**Proposed Temporary Container Storage Yard, Container Vehicle Park, Vehicle Repair Workshop, Logistics Centre, Warehouse and Open Storage of Miscellaneous Goods with Ancillary Facilities for a Period of 3 Years and Associated Filling of Land in “Agriculture” Zone, Various Lots in D.D. 87, Hung Lung Hang
(Compliance with Approval Condition (a) for Planning Application No. A/NE-HLH/77)**

DSD Comment on DIA Report

Drainage Impact Assessment Report

DRAWING NUMBER
FIGURE 3

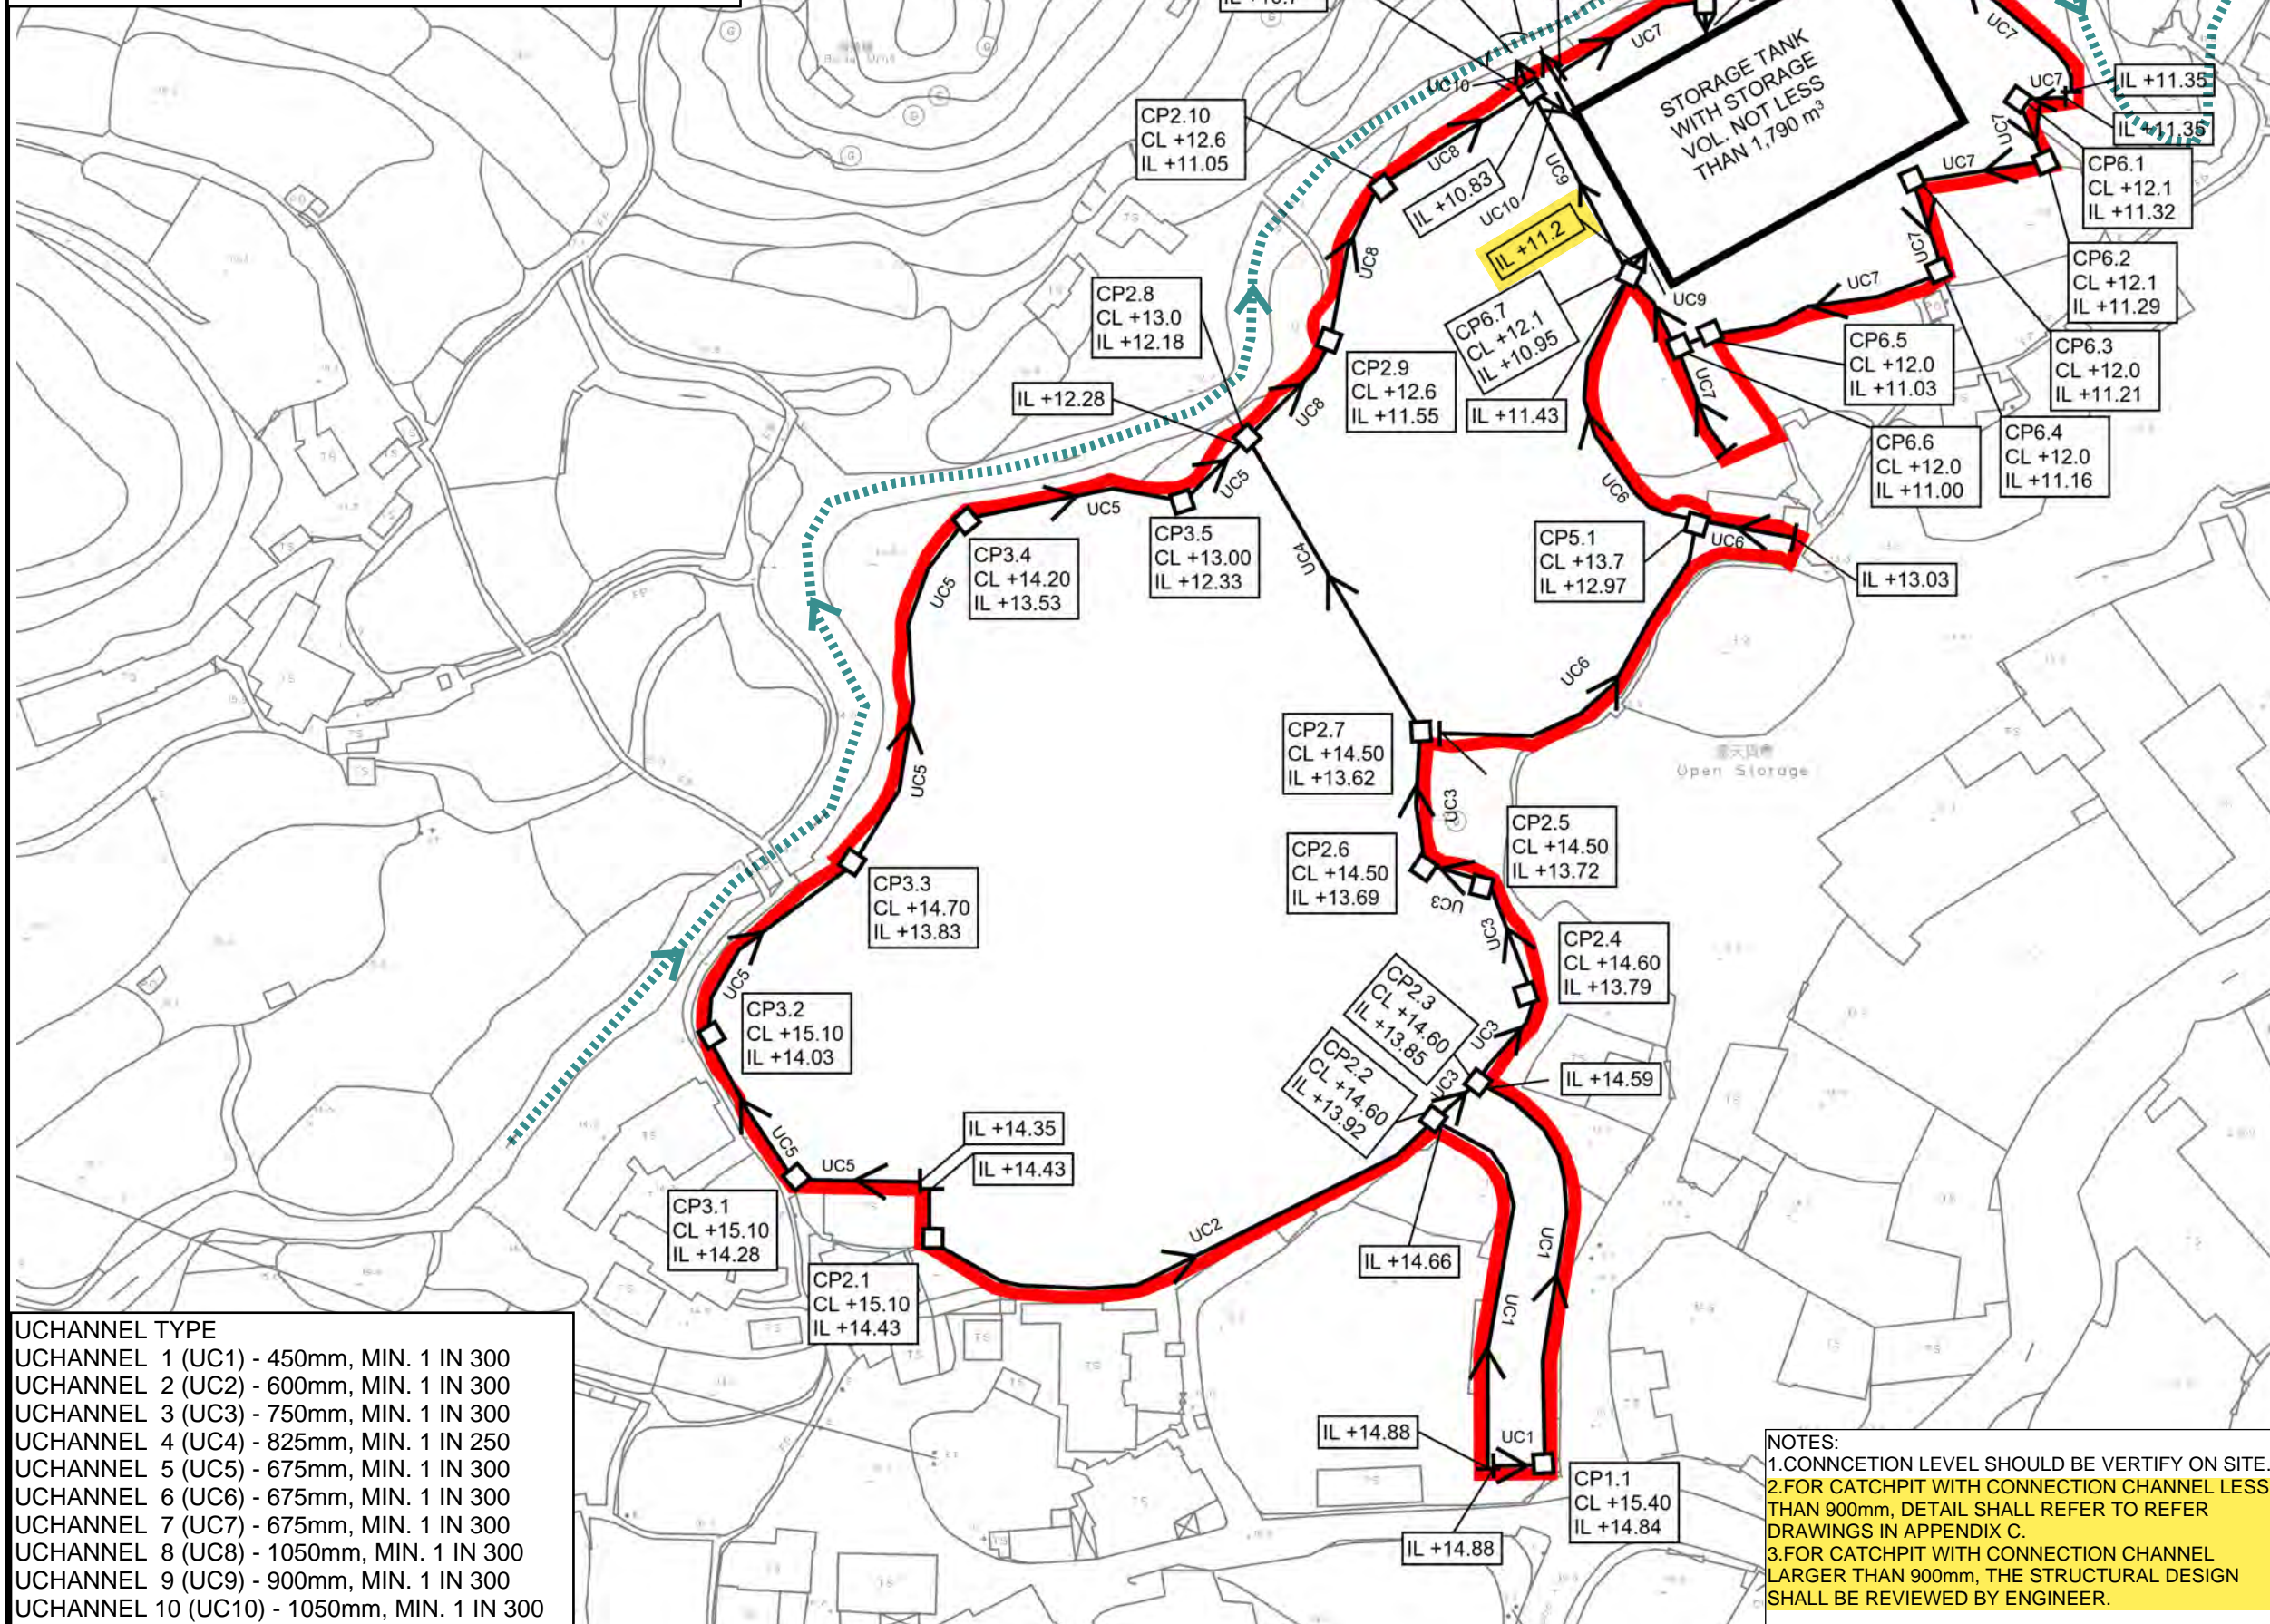
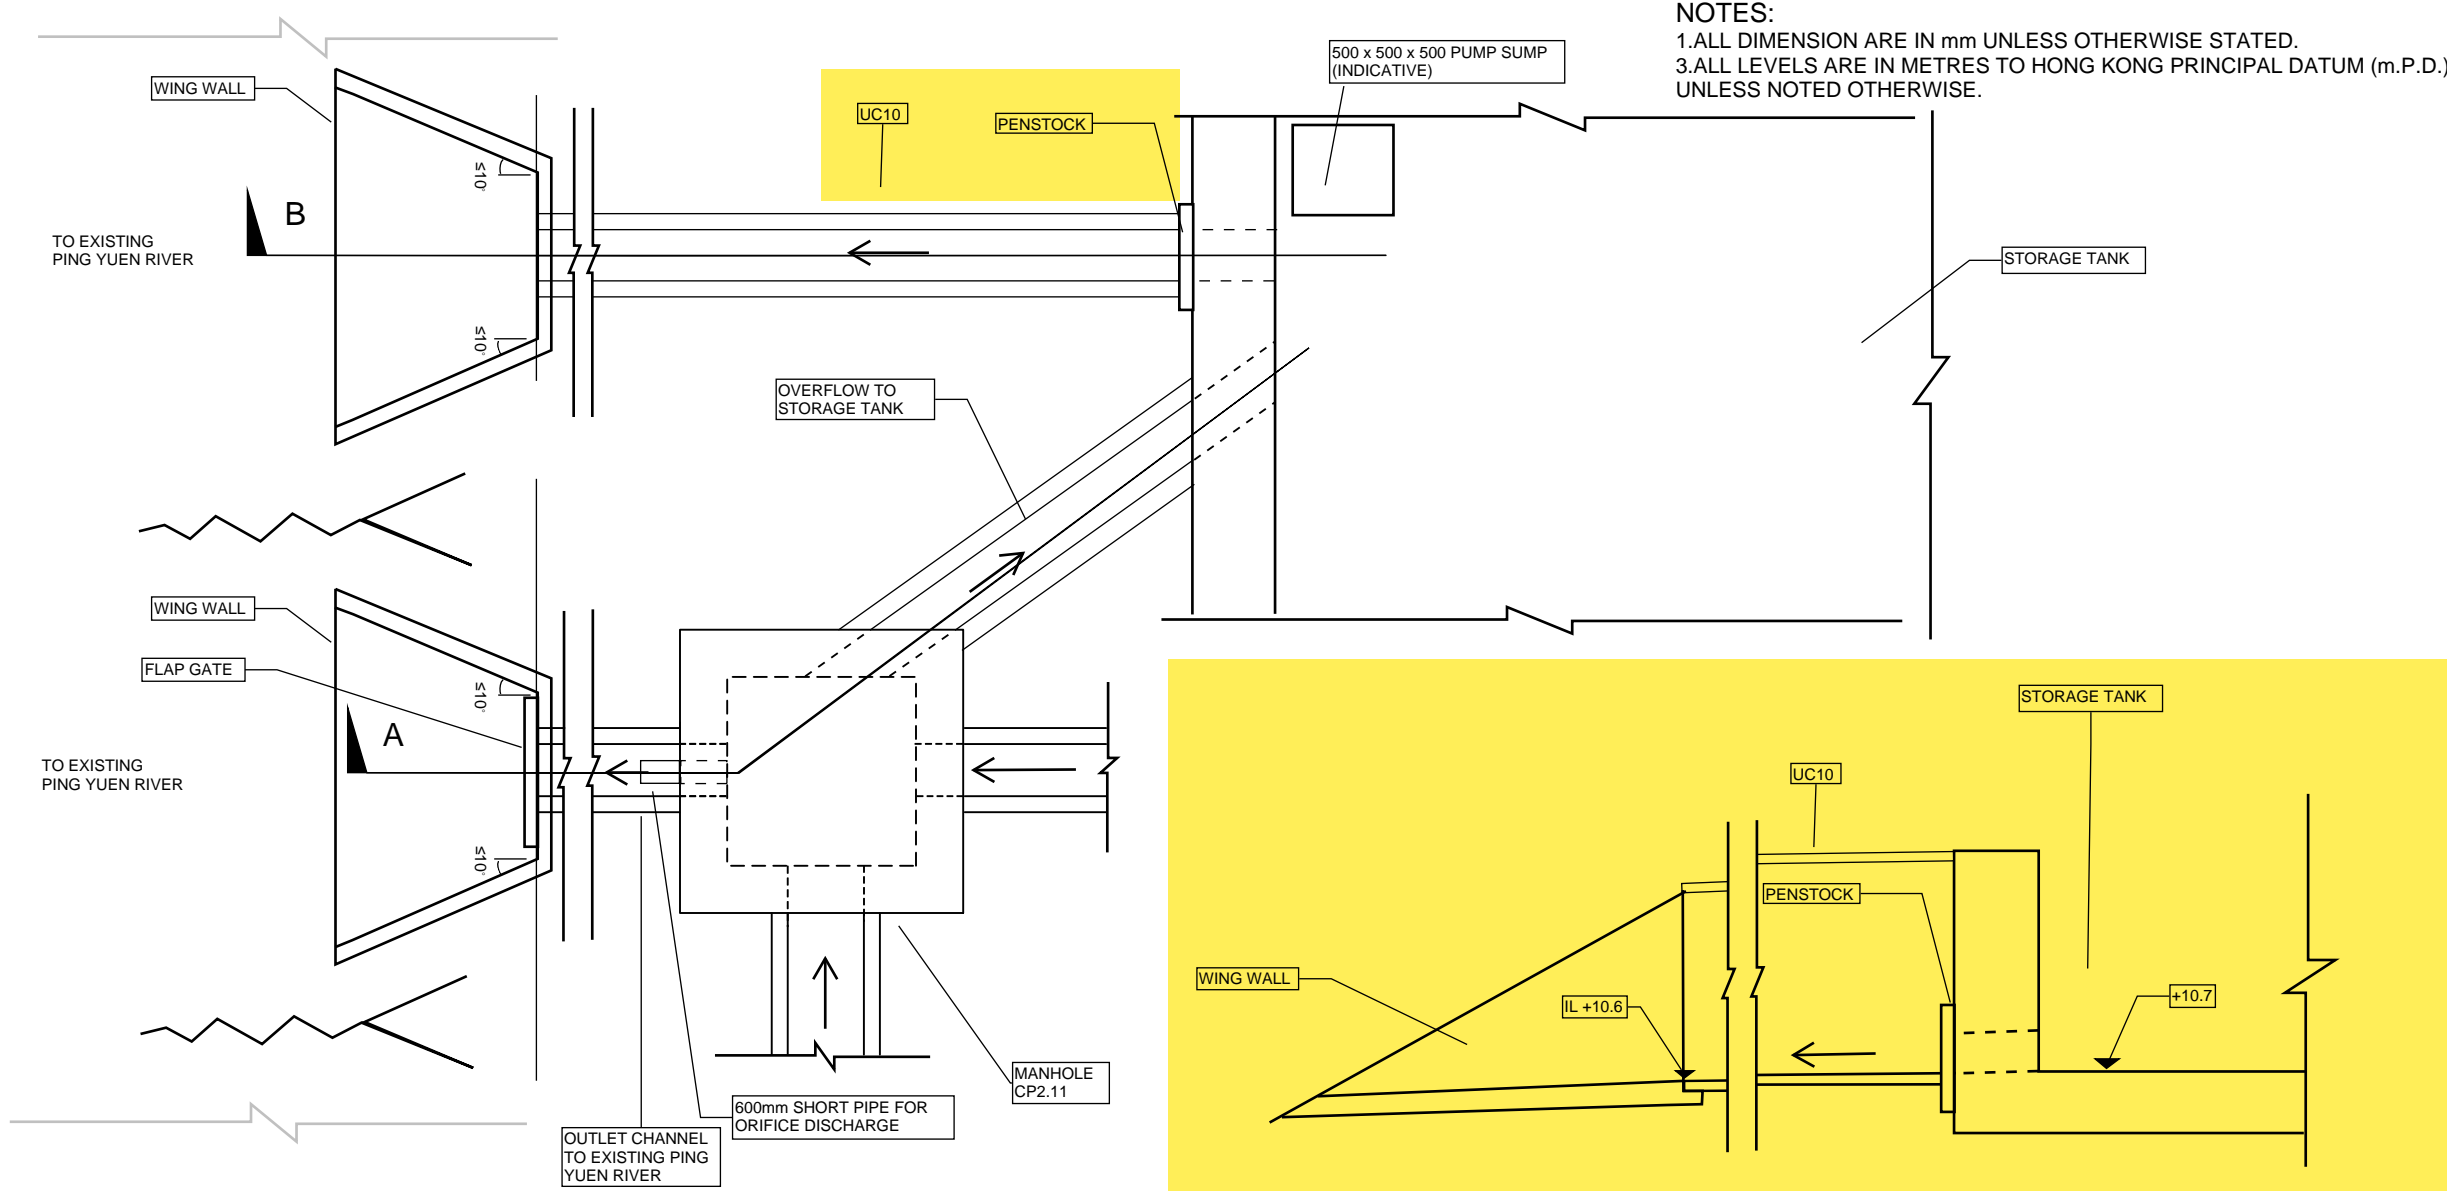
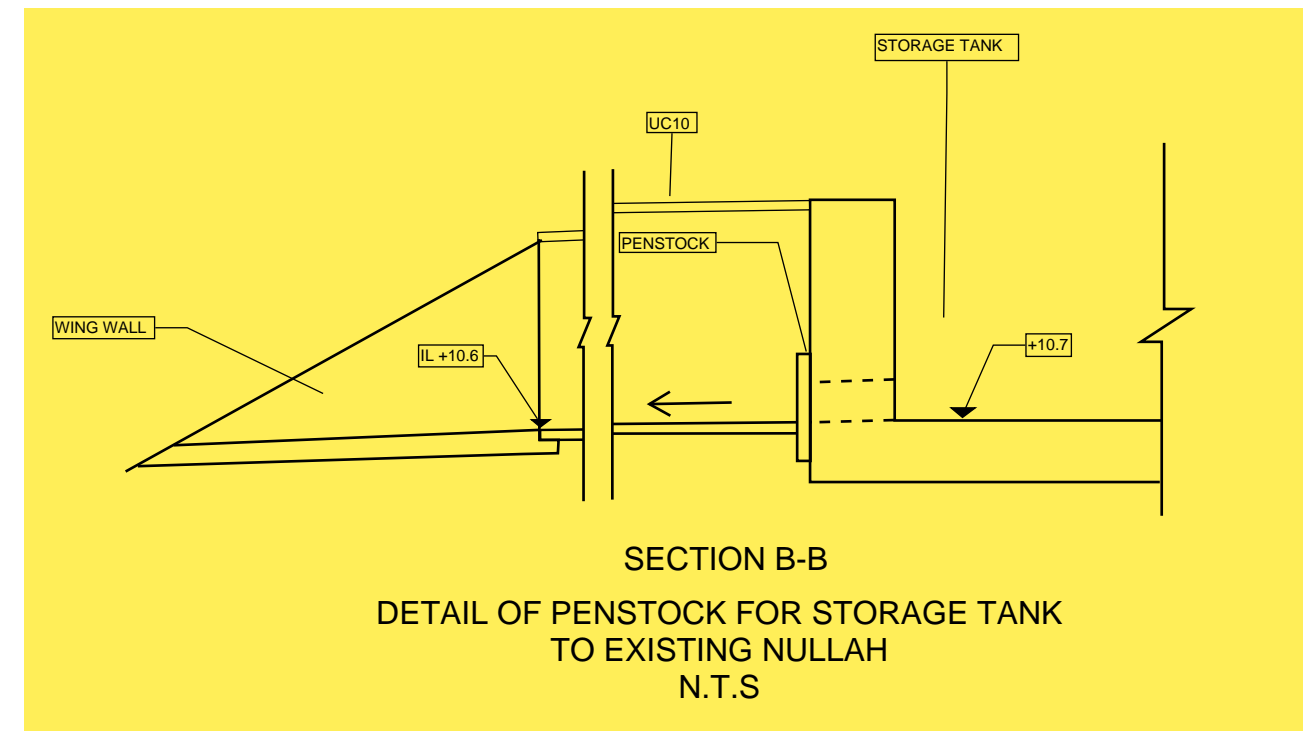
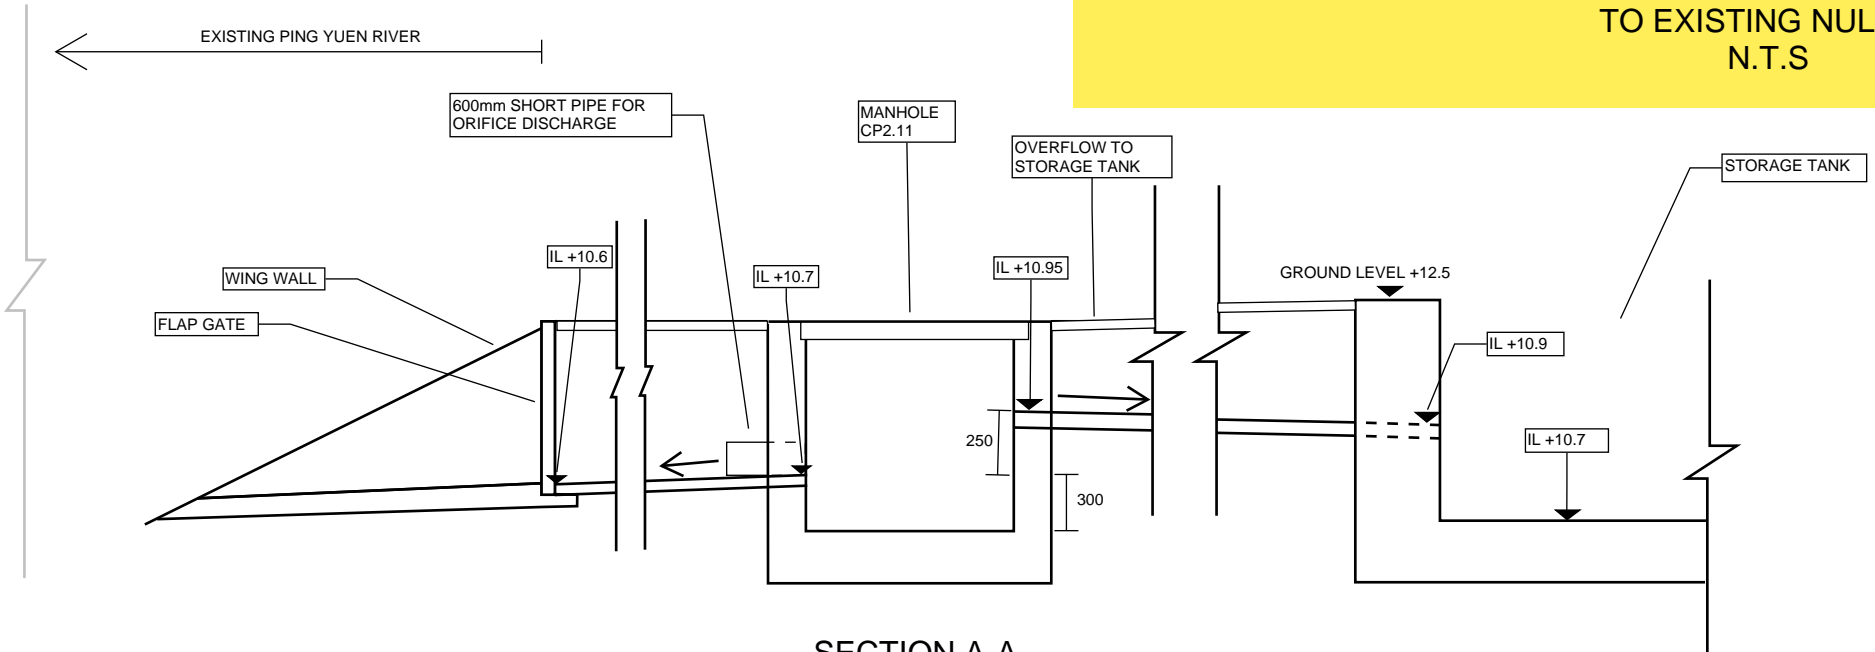
Item	Comments	Responses
1	Para. 3.1.3 (6): It appears that the 240 mins duration should be read as 120 mins.	Noted. Para.3.1.3 (6) is updated accordingly.
2	Figure 3 & Figure 5	
a	please advise the details at CP2.9 and clarify how the flow is distributed to the storage tank and downstream CP2.11;	The channel connecting from CP6.7 to storage tank is a overflow channel to allow more effective storage from channels to the tank. The channel invert level is added on Figure 3 for reference.
b	please advise the existing invert level of Ping Yuen River at the proposed discharge point;	Please note according to the CEDD, GEO Spatial Data, the invert level of Ping Yuen River at discharge point is about + 10.52 mPD.
c	please indicate the location of penstock at the plan view. A section view shall also be provided; and	Noted. Please refer to updated Figure 5 for location and section of penstock.
d	please review if the typical details in Appendix B can be applied to CP2.11, where the U-channel of 1050mm width will be connected to the catchpit; and	Note is added in Figure 3 "FOR CATCHPIT WITH CONNECTION CHANNEL LARGER THAN 900mm, THE STRUCTURAL DESIGN SHALL BE REVIEWED BY ENGINEER."

DWG. TITLE
LAYOUT PLAN

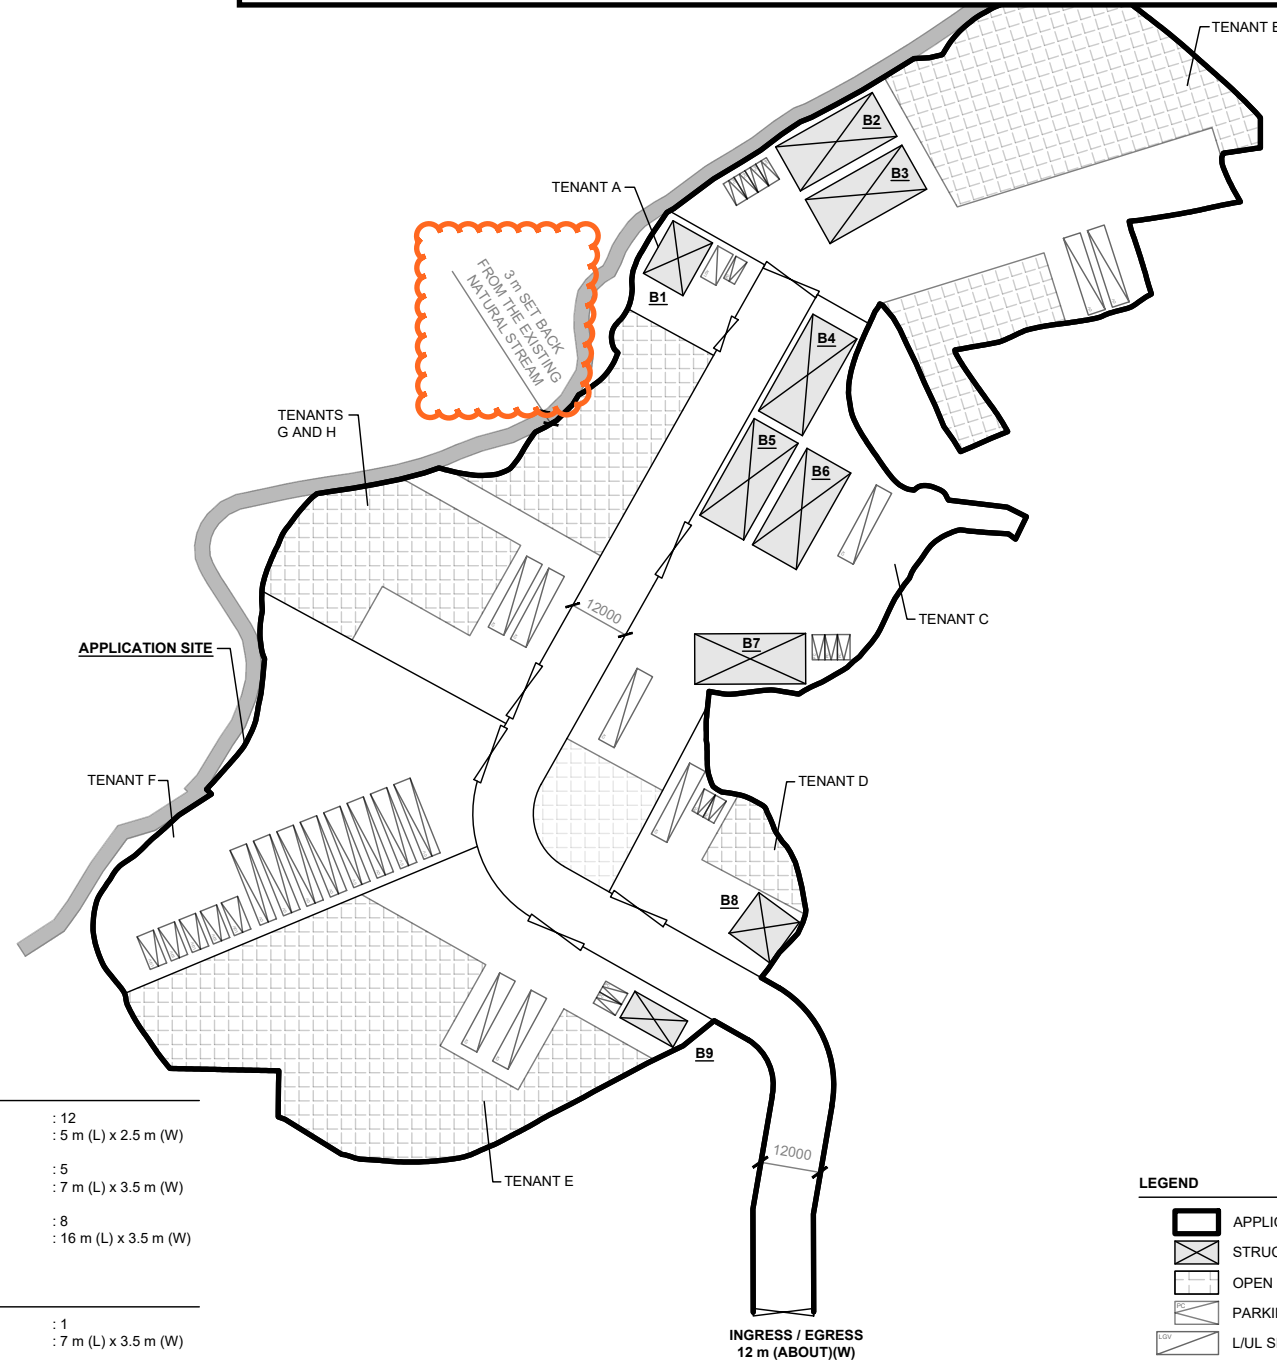
3. The proposed storage tank was not shown on Appendix C of the Drainage Impact Assessment. The development shall ensure the proposed storage tank is consistent with the proposed layout of the development.
